เอกสารเพิ่มเติมแนบท้ายรายละเอียดสเปค
(ADDENDUM)

THREE-PHASE TRANSFORMERS FOR 22 kV AND 33 kV 50 Hz DISTRIBUTION SYSTEMS WITH ABILITY TO WITHSTAND SHORT CIRCUIT

Specification No. RTRN-035/2561

เอกสารเพิ่มเติมแนบรายละเอียดสเปค 4
(ADDENDUM 4)

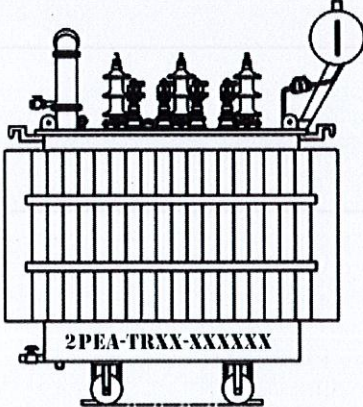
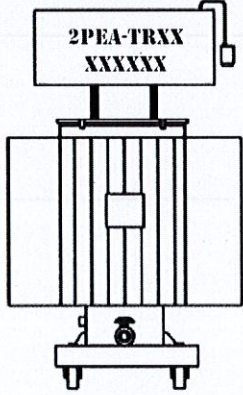
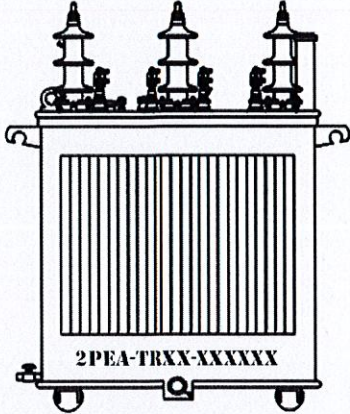
การพิมพ์หมายเลข PEA หม้อแปลง ตามข้อ 1c.13 Marking

ให้คู่สัญญาพิมพ์หมายเลข PEA หม้อแปลง ตามรายละเอียด ดังนี้

- (1) Font ของตัวอักษรและตัวเลข คือ **STENCIL**
- (2) ความสูงของตัวอักษรและตัวเลข ไม่น้อยกว่า 3 นิ้ว
- (3) ตำแหน่งการพิมพ์หมายเลข PEA หม้อแปลง ดังนี้

ชนิดของหม้อแปลง	ตำแหน่งการพิมพ์
<p>(1) หม้อแปลง 3 เฟส ชนิด Conservator Type</p>	<div style="display: flex; justify-content: space-around; align-items: center;">   </div> <p>จุดพิมพ์หมายเลข PEA บริเวณส่วนล่างด้านหน้า และ ถังอะไหล่ของหม้อแปลง</p>

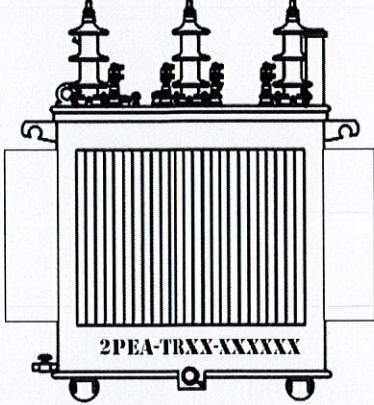
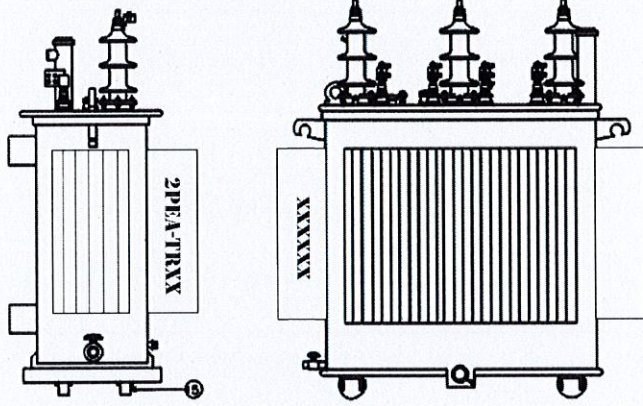
ชนิดของหม้อแปลง	ตำแหน่งการพ่น
<p>(2) หม้อแปลง 3 เฟส ชนิด Seal Type มีเฉพาะครึ่งด้านหน้า</p>	 <p>จุดพ่นหมายเลข PEA บริเวณส่วนล่างด้านหน้าของหม้อแปลง หรือ</p>
	 <p>จุดพ่นหมายเลข PEA บริเวณด้านข้างของหม้อแปลง</p>

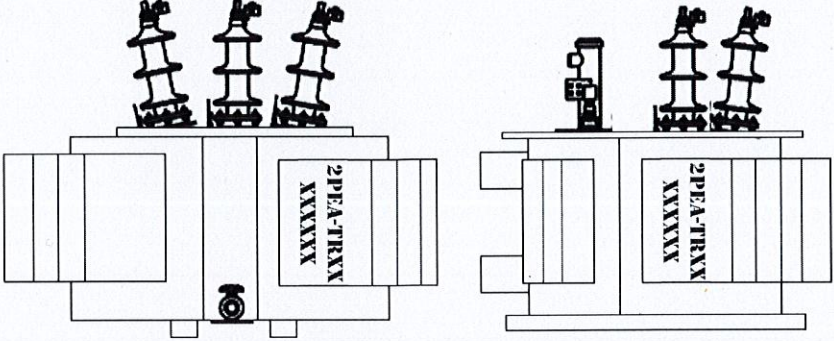
ชนิดของหม้อแปลง	ตำแหน่งการพ่น
<p>(4) หม้อแปลง 3 เฟส ชนิด Seal type แบบ 3D</p>	 <p>จุดพ่นหมายเลข PEA บริเวณครีbsd้านหน้า และ ครีbsd้านข้างของหม้อแปลง</p>
